**MONTGOMERY COUNTY HISTORIC PRESERVATION COMMISSION**  
**STAFF REPORT**

<b>Address:</b>	7019 Eastern Avenue, Takoma Park	<b>Meeting Date:</b>	9/22/10
<b>Applicant:</b>	Sabrina Eaton (Rick Vitullo, Architect)	<b>Report Date:</b>	9/15/10
<b>Resource:</b>	Contributing Resource Takoma Park Historic District	<b>Public Notice:</b>	9/8/10
<b>Review:</b>	HAWP	<b>Tax Credit:</b>	None
<b>Case Number:</b>	37/3-10AAA	<b>Staff:</b>	Anne Fothergill
<b>PROPOSAL:</b> Rear addition

**DRAFT August 11, 2010 HPC Meeting Transcript**

EXISTING  
FRONT ELEVATION  
1/4" = 1'-0"

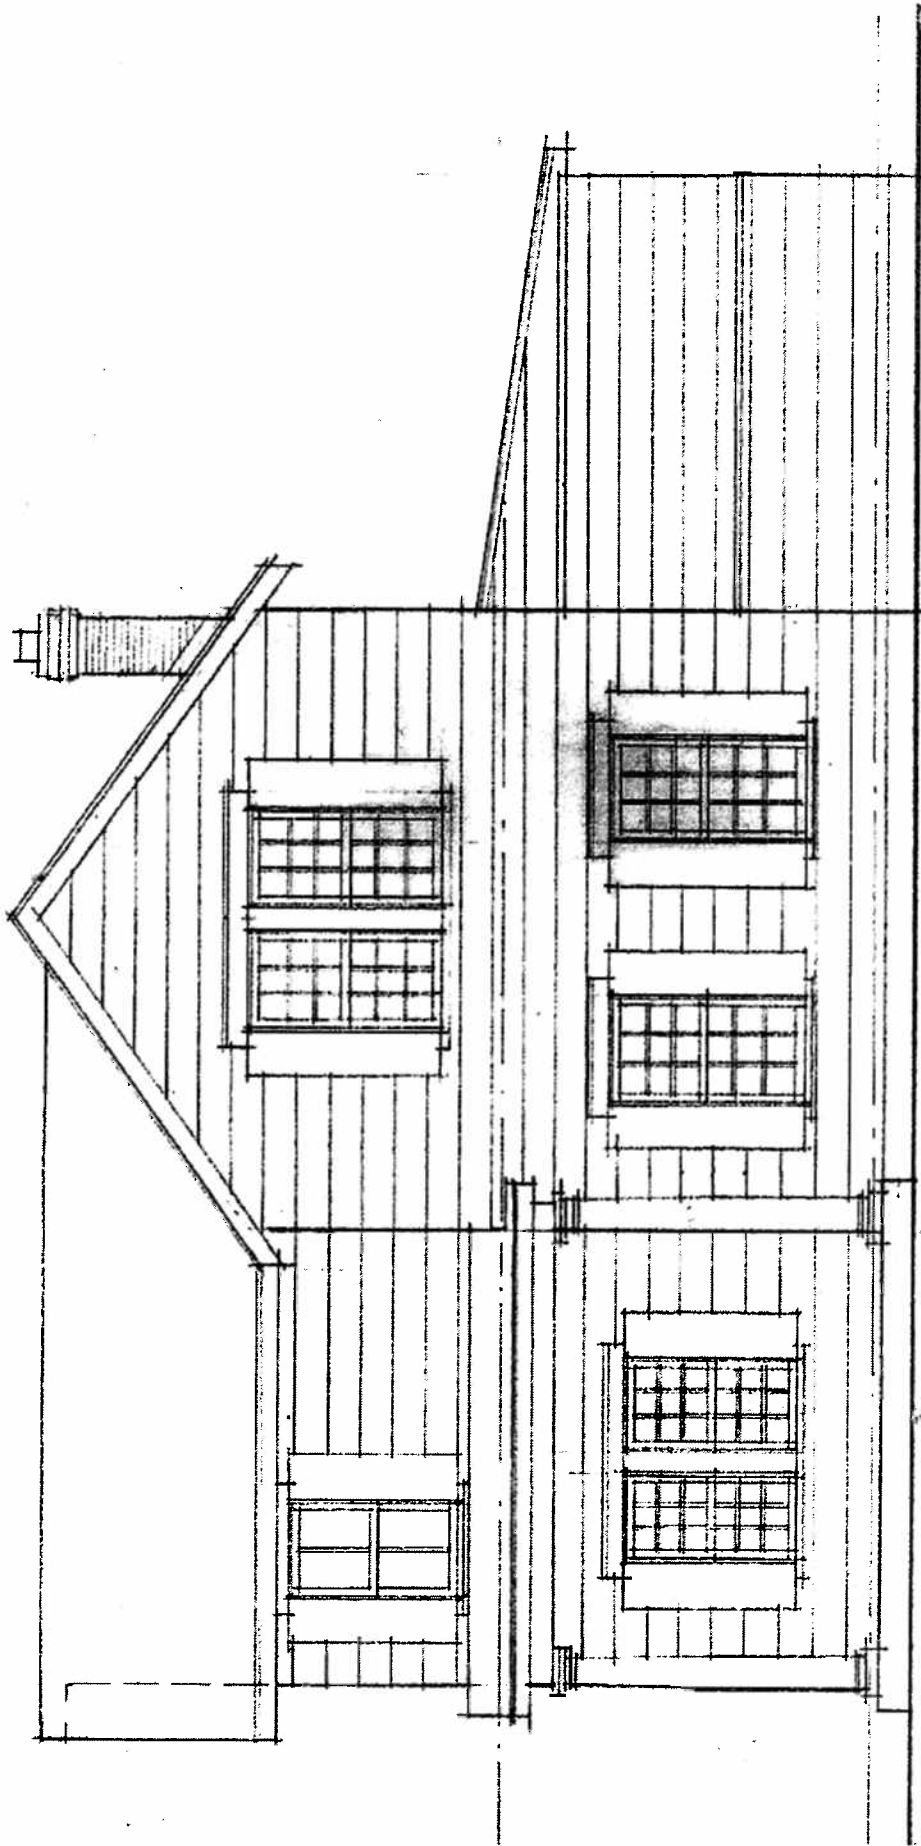
MR. JESTER: On circle 9, which shows the existing front elevation, the majority of the windows are nine-over-nine double hungs, but then there is a two-over-two, which is over the entry porch. Are we saying that that was original, that it had this kind of mix of light styles on the existing house?

MR. JESTER: Or that the nine-over-nines are the originals, and the two-over-two may have been a later replacement?

MR. VITULLO: Yeah, I didn't study those windows. They're not part of the scope of this project. But I think they are either original or very old.

REAR ELEVATION  
14'-11" x 21'

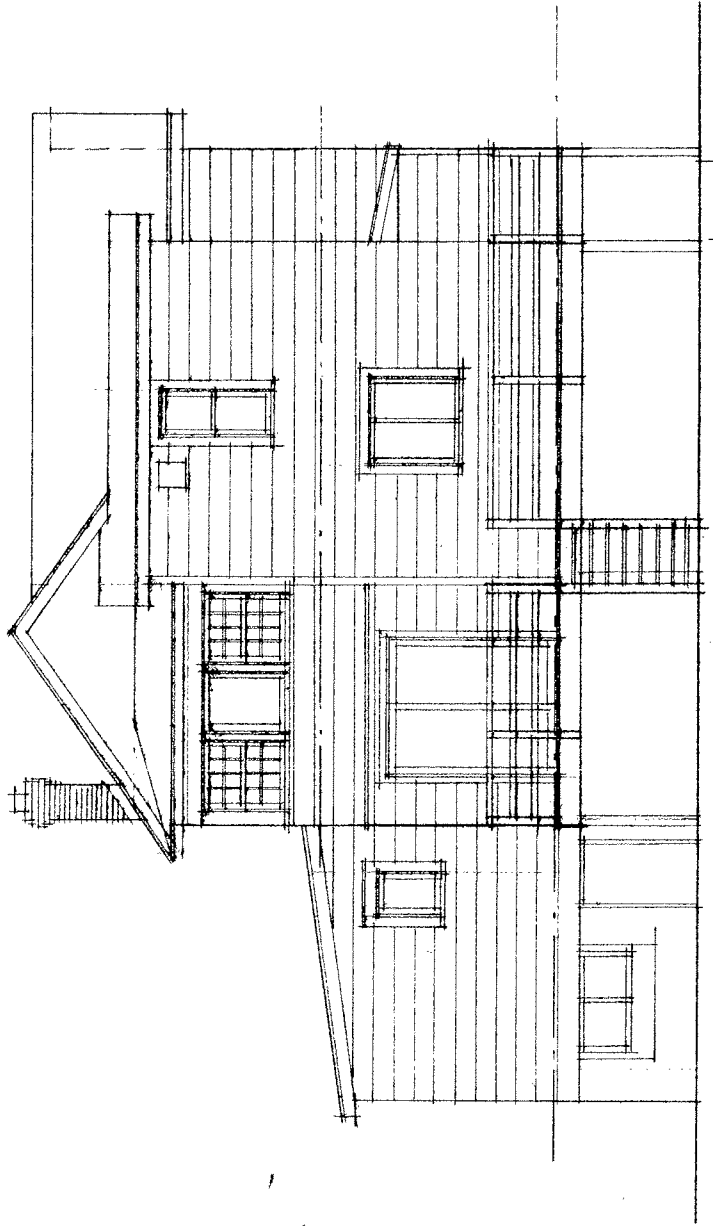
There are a few details of the proposal that the Commission may want to comment on. The proposed fenestration with the numerous types and sizes may not be compatible with the historic house. Generally, for the roof of a rear addition, the guidelines and the Commission support the roof ridge being lower.

The window in the rear elevation, I'm not sure which --

MR. VITULLO: Circle 13, thank you, those are egress windows in the back, and they are double hung. So those would match the style of the other, the other windows in the house.

REAR ELEVATION  
1/11/13  
BENTON

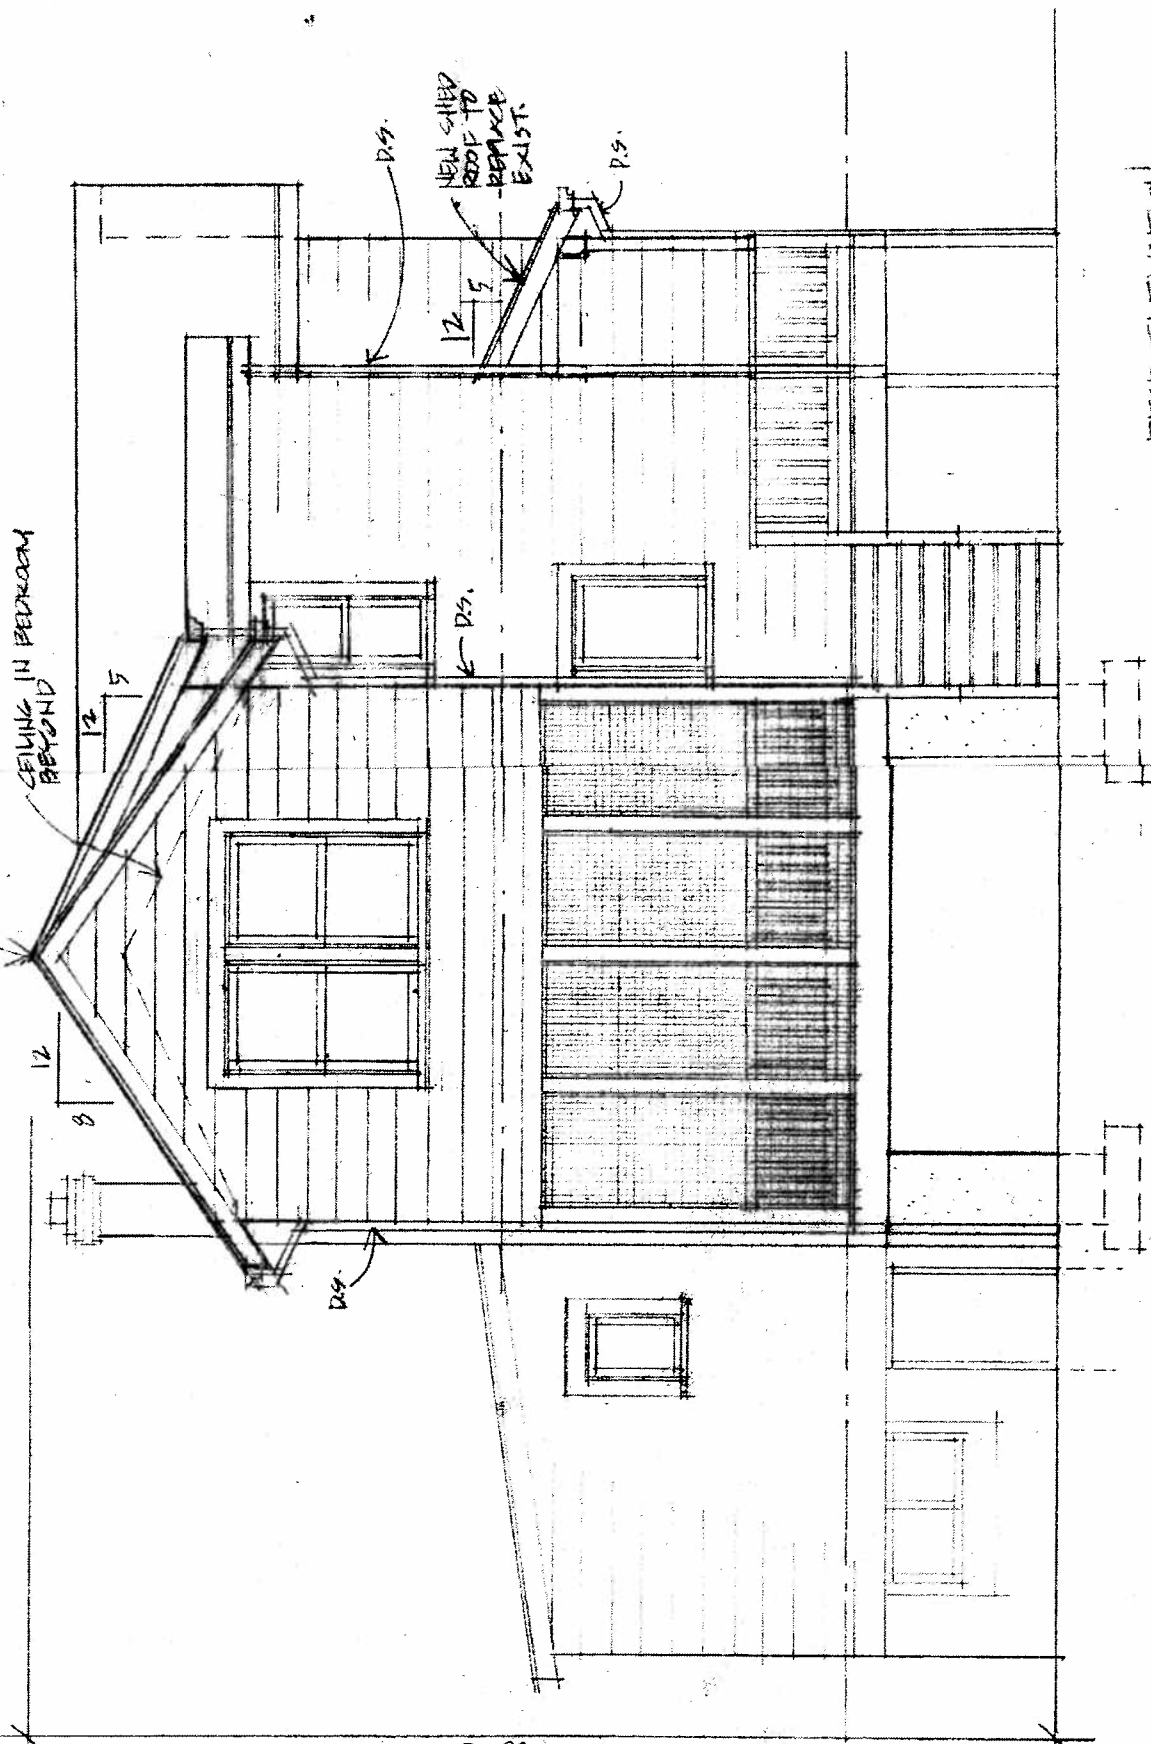
MS. MILES: Well, my concern, I have a couple of concerns about the roof. I think there are some mechanical concerns that others are better able to address than I am, but to me, to have an addition of such substantial size be only microscopically lower than the original house, the massing reads as a very large mass. And I also don't think that the shed dormer works next to the gable ended roof next to it.

But I do agree with Commissioner Miles on the massing of the dormer, the shed dormer on the one side. I think that, maybe you could address that, and the windows.

MS. HEILER: I also don't have a problem with the massing. However, I would agree with Commissioner Miles that the shed dormer seems to present a problem. And I think it's not just that the window is different from the others, but the whole combination of this very large window and shed dormer just give an importance to that end of the house that makes it look larger than the main house, even though it isn't.

MR. JESTER: And just one other comment, kind of more practically about the massing proposed. I think the shed addition on, I guess it's connected, if you look at the, I guess it's the right side elevation, you've got a considerable number of roof areas that are coming down to basically one gutter.
